RESPONSE TO SUBMISSION

LANDSCAPE
MELROSE PARK SOUTH

OPEN SPACES
MELROSE PARK SOUTH

OPEN SPACES - WEST SITE
MELROSE PARK SOUTH

Coordination with Stormwater Plan, WSUD, Bulk Earthworks, and Grading

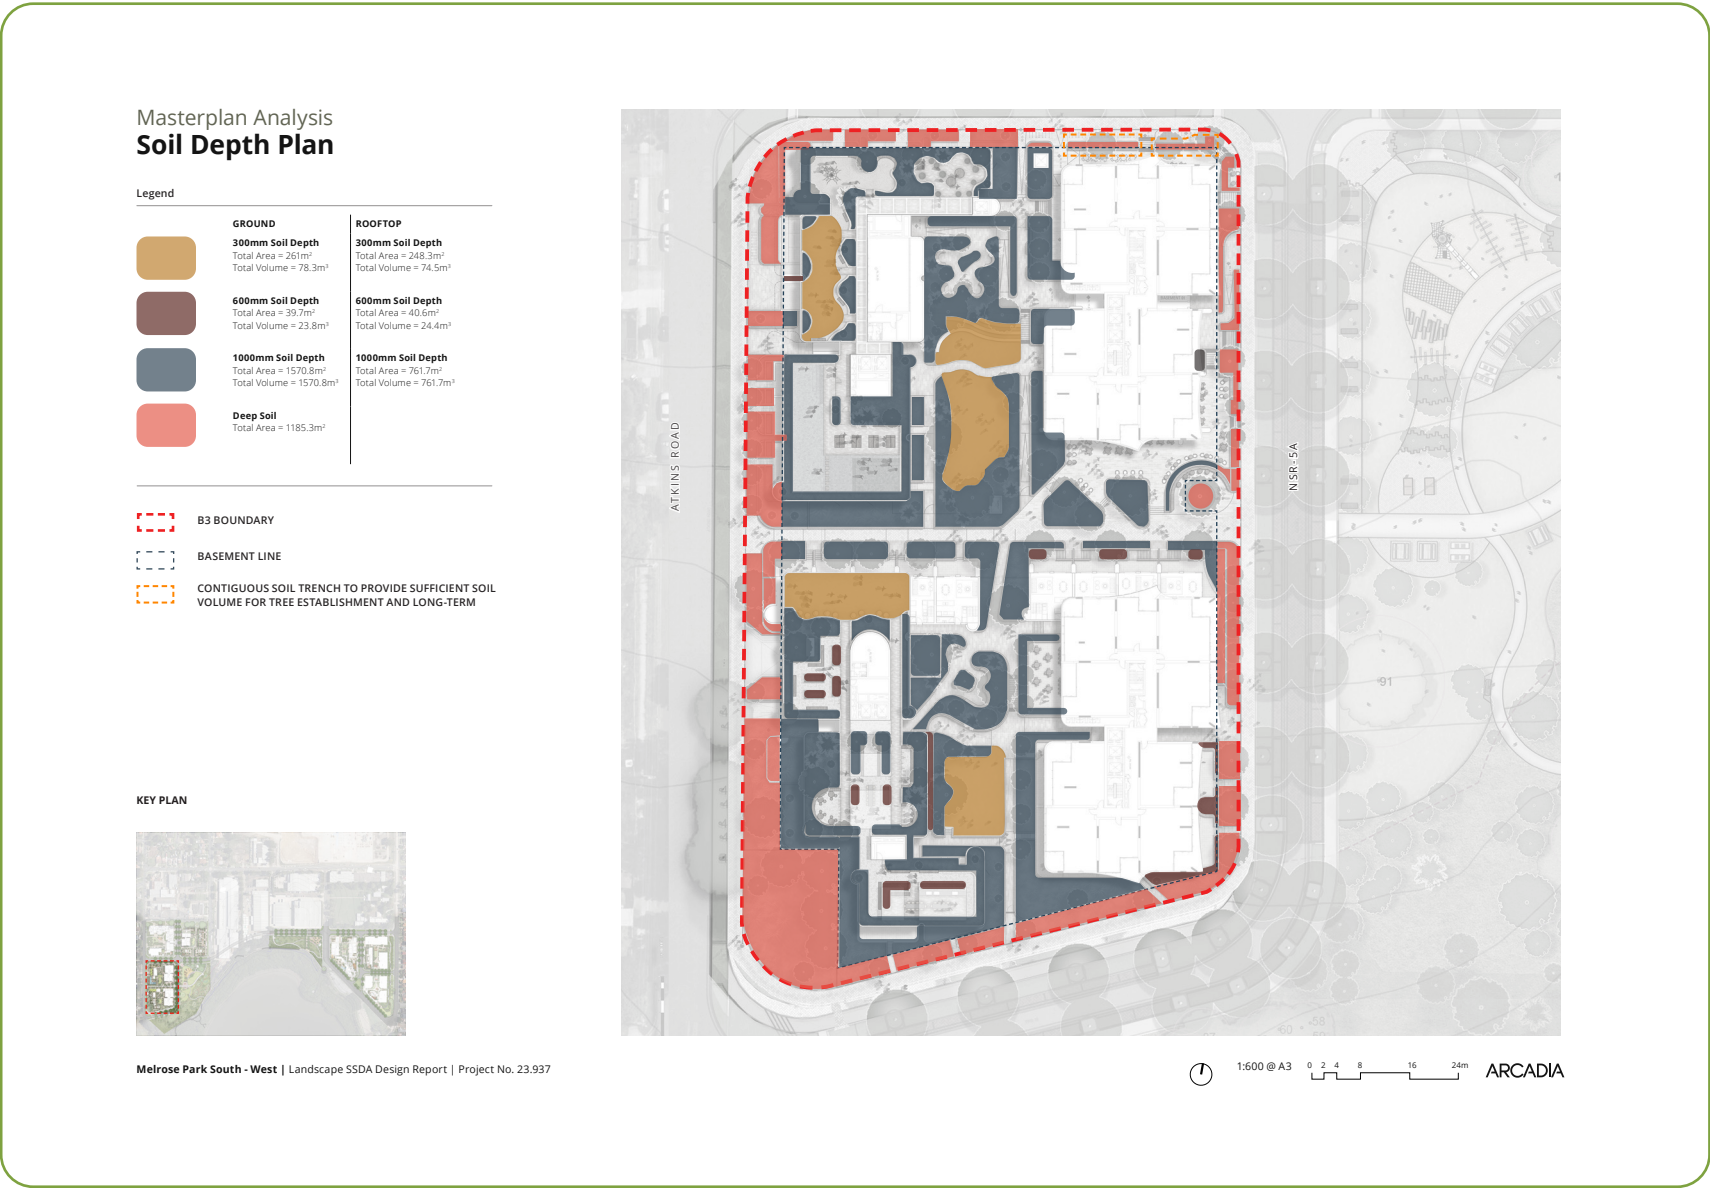
- + Council notes very few stormwater pits are shown within the landscaped areas. Coordination with bulk earthworks and grading is also not provided.

Refer to updated B3 softworks plan and MPS-B2-L-400 plant schedule in appendix for amended species and matrices updated to responded to site conditions (i.e. sunny and shady positions).

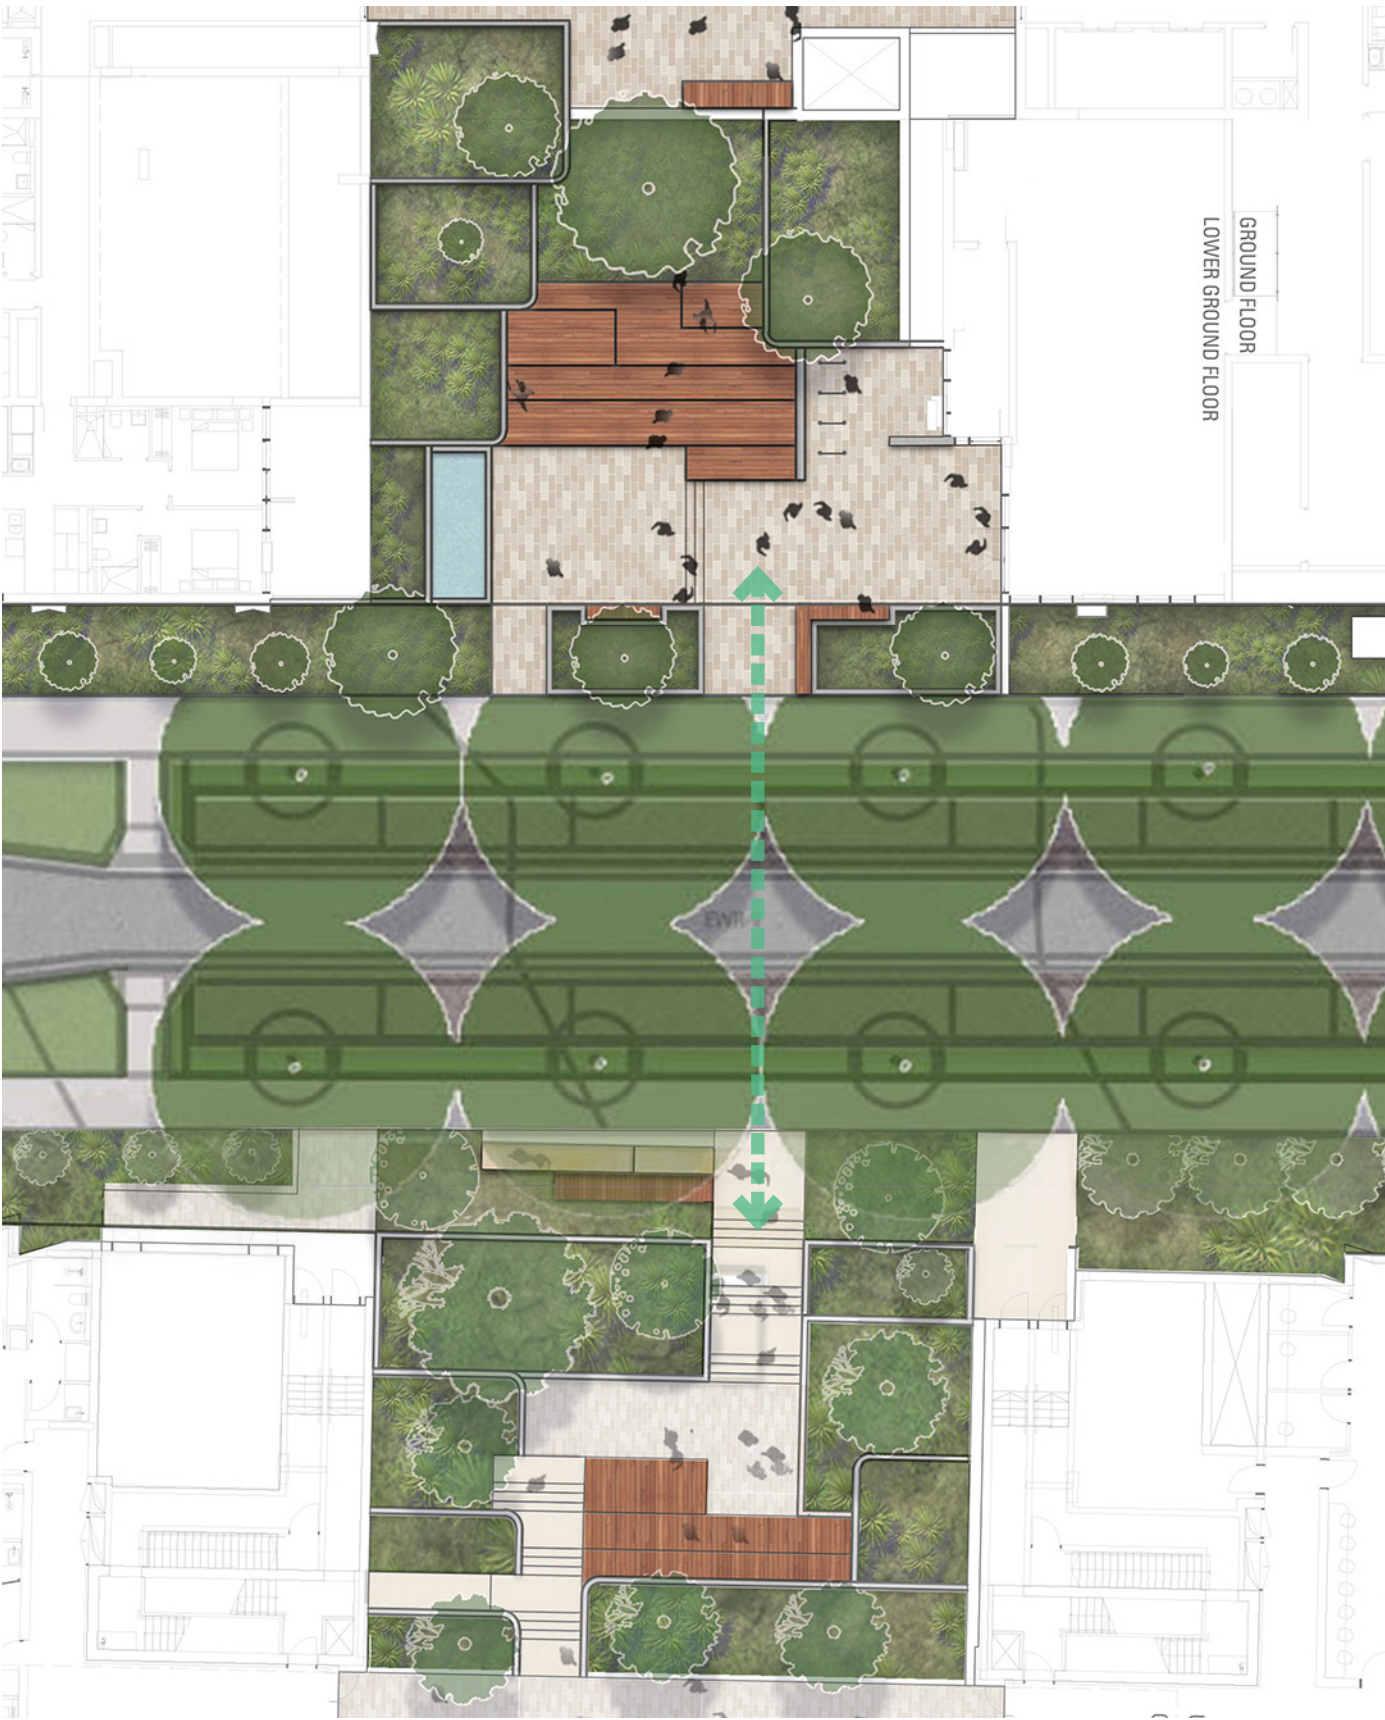
The SE and NW lobbies still need further refinement, in particularly column placement and access to entry doors.

The NW lobby includes a double height void that is unresolved, as it currently straddles the ground level mail, parcel and plant rooms. Further review of this entry is required to resolve the form and character of this double height void.

There does not appear to be a gate to the open steps leading to the courtyard adjacent to the NW lobby, which may raise CPTED issues.

Rooftop shade structure

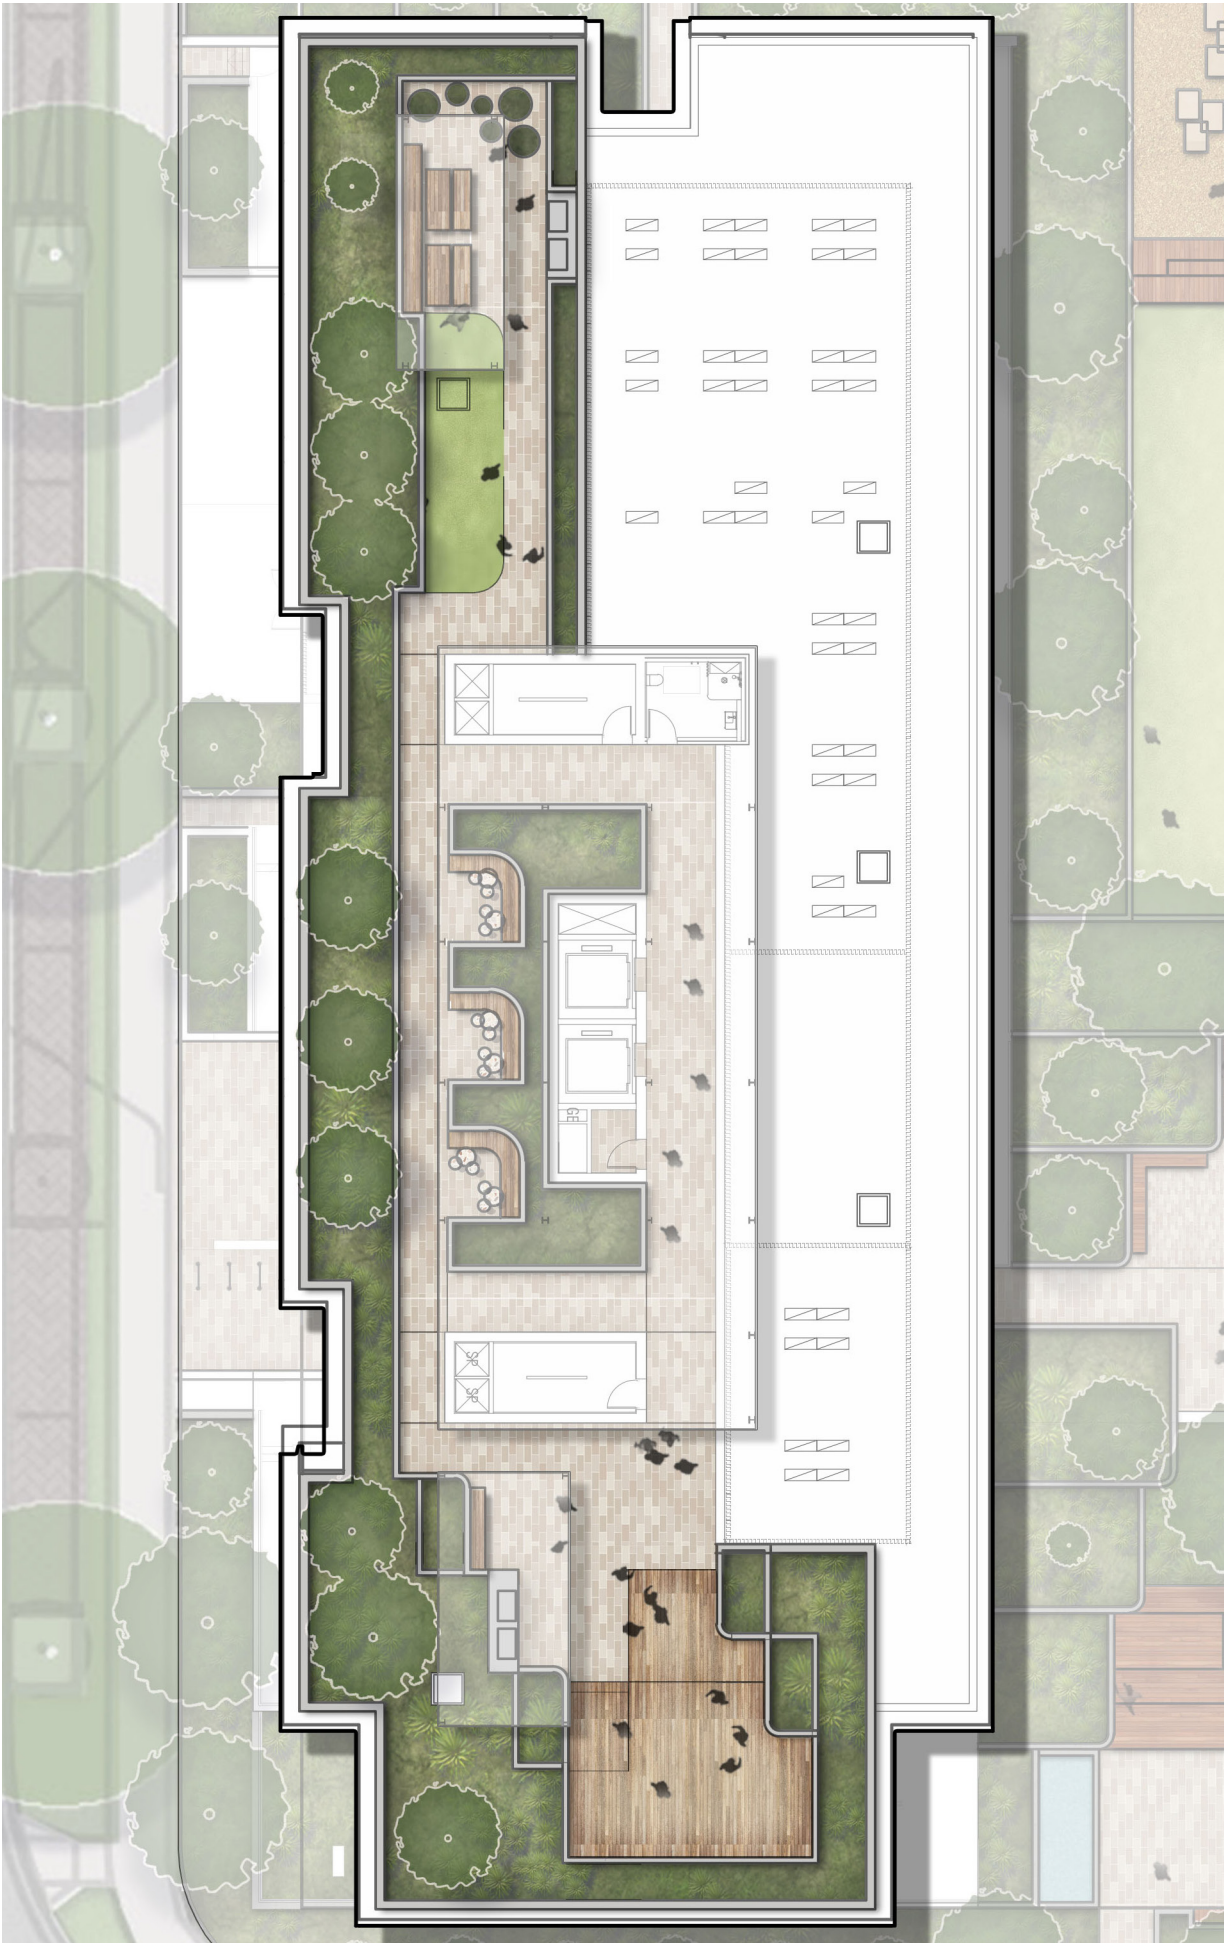
The roof feature is excessively large and does not specifically respond to the amenity requirements of the rooftop open space. It should be reduced in scale to a simple roof form spanning the service cores only, which will reduce its visual and physical bulk. The covered area should relate to the function of the spaces it protects and needs to demonstrate a relationship with the adjoining buildings. The Panel suggests decreasing its current size to increase the amenity of the space.

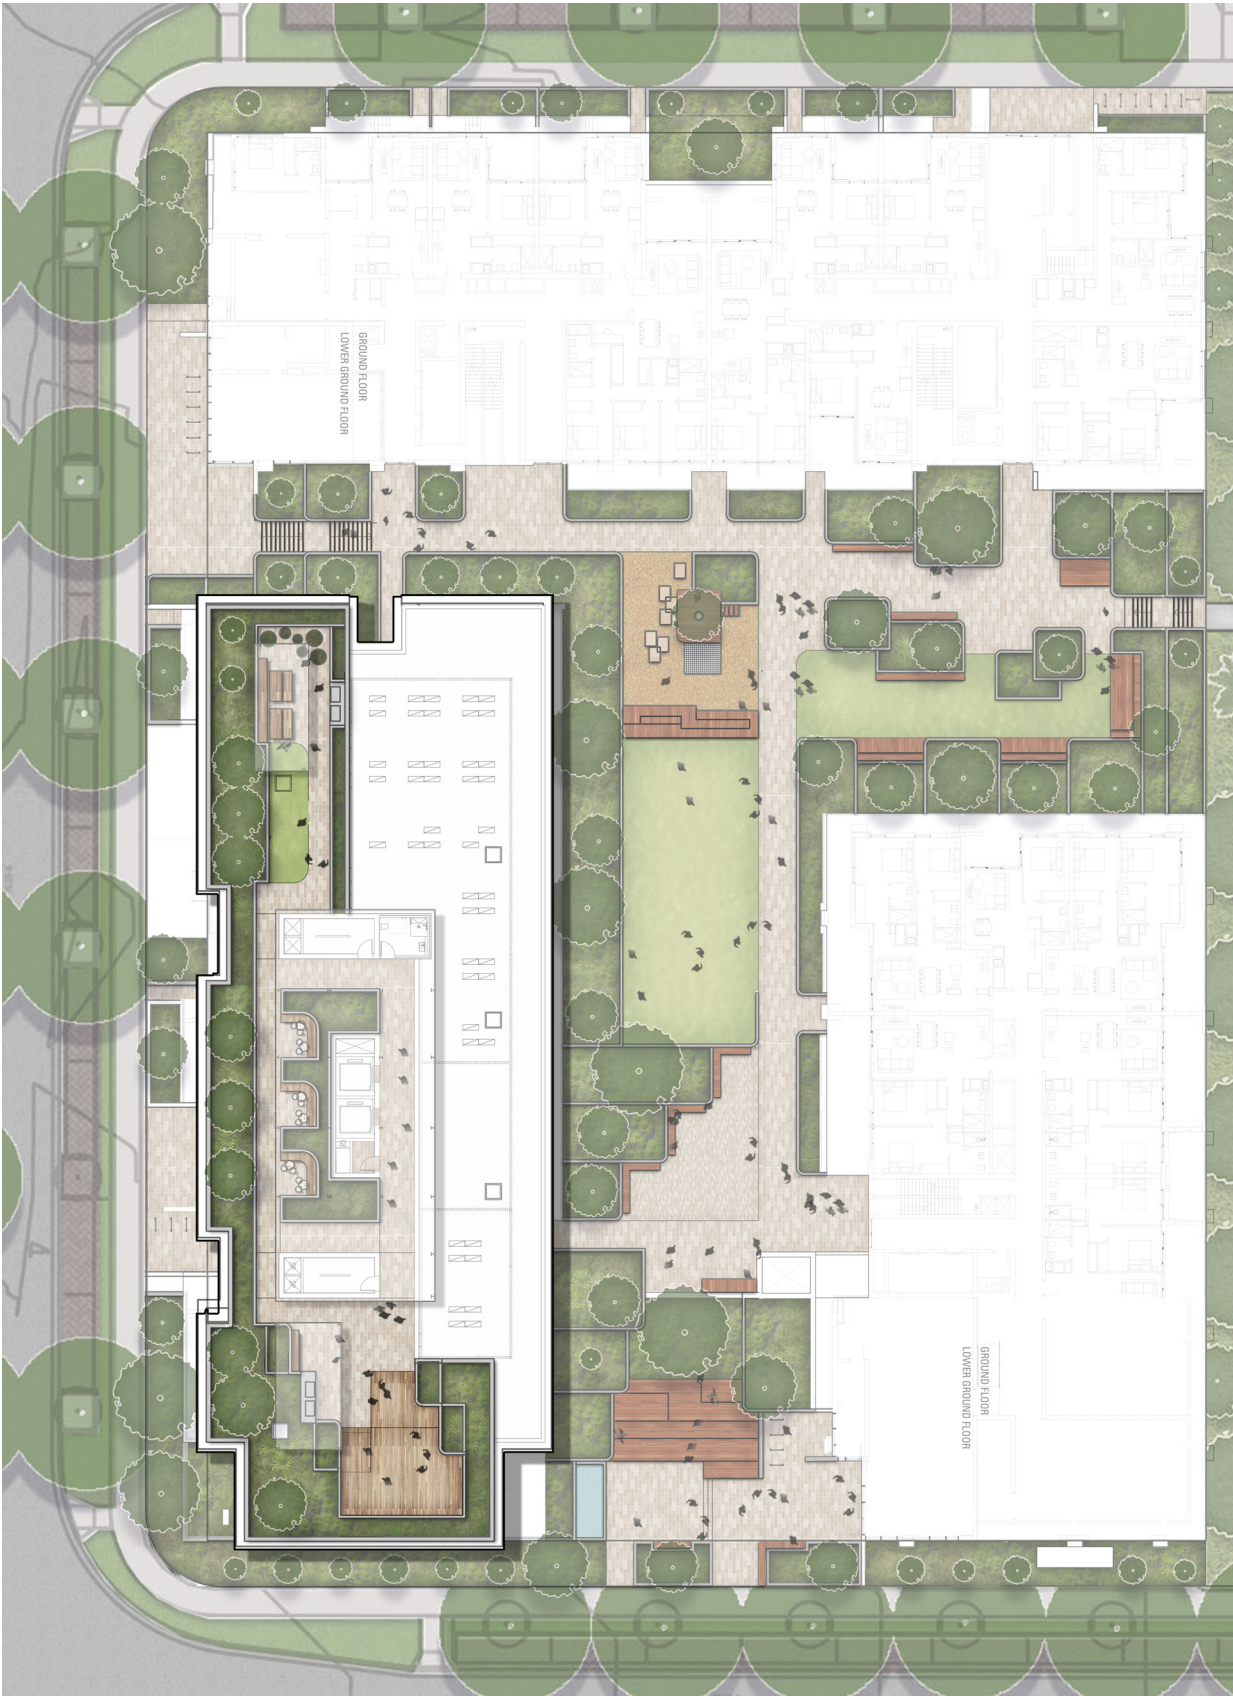
The rooftop communal open space needs to be coordinated with the proposed roof feature. At present the landscape and uses below are not coordinated with the roof above including significant planting under the roof and BBQ gathering area partially not covered by the roof. Planting under impervious roof should be avoided. Specifically, it is noted that canopy trees are shown under the roof form.

On the rooftop planter wall heights are not evident in the landscape or architectural drawings. Planter depths and volumes must be provided in accordance with Council and ADG requirements to ensure the success of the future landscape.

The two banks of bicycle parking along the western elevation appear to block the NW entry in the one case, and impact on the visual and physical amenity of the private open space of an adjacent street facing apartment in the other. Both of these bicycle parking locations appear not to be suitable and should be relocated.
